## SERVICE BULLETIN

**APPLICABILITY:** 2017-18MY Impreza  
 2018MY Crosstrek  
 2018MY Legacy and Outback  
 2018MY BRZ

**NUMBER:** 15-211-17R

**SUBJECT:** Reprogramming File Availability for Additional Optimization of Harman Gen 3 Audio and Navigation Head Units

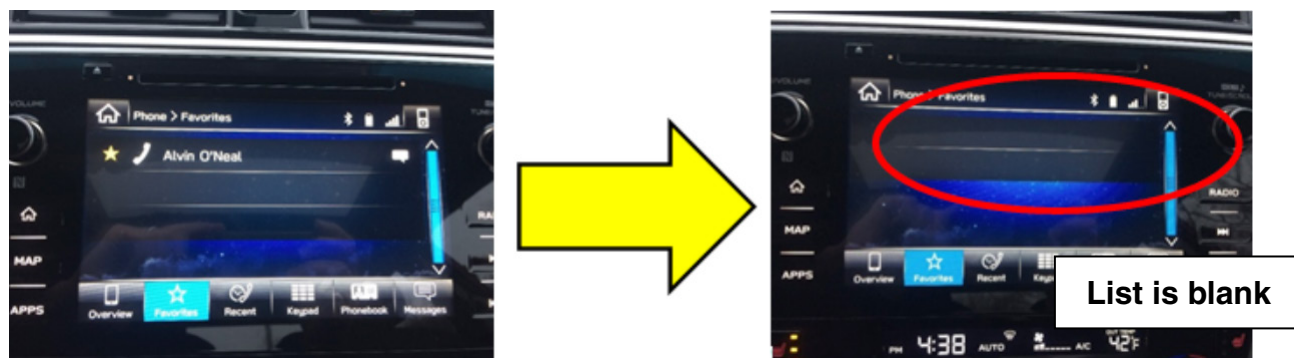
- On 2018MY Legacy / Outback models with Navigation (High) head units, the update corrects a condition where the head unit remains powered even after the ignition is OFF and the driver door is opened.
- Corrects for a condition where the SXM presets become lost and only “Initializing” appears as shown below.

- Corrects for condition where only the star field background is displayed (without icons) after the HOME button is pressed.

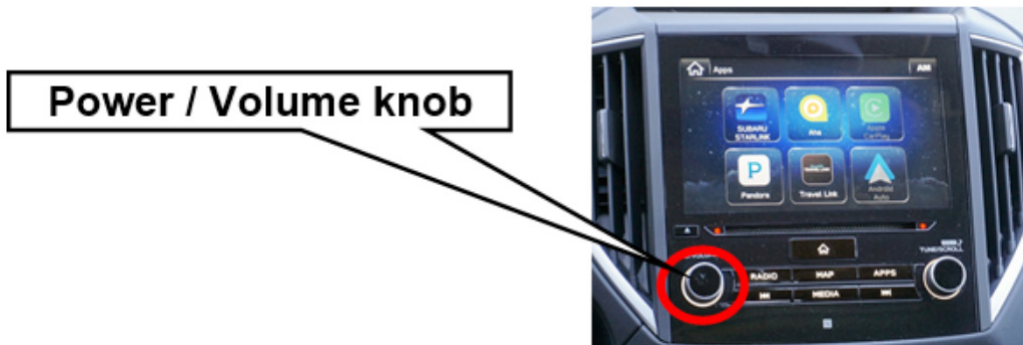
**PREVIOUS Version:** The head unit power is turned OFF by pressing the Power/Volume knob for 4 or more seconds. On the next ignition ON, the display remains OFF / black while the audio begins playing automatically. This was the prior characteristic operation.

**NEW Version:** The head unit power is turned OFF by pressing the Power/Volume knob for 4 or more seconds. On the next ignition ON, the display remains OFF / black and the audio will also be OFF until the Power/Volume knob is pressed to turn the head unit back ON.
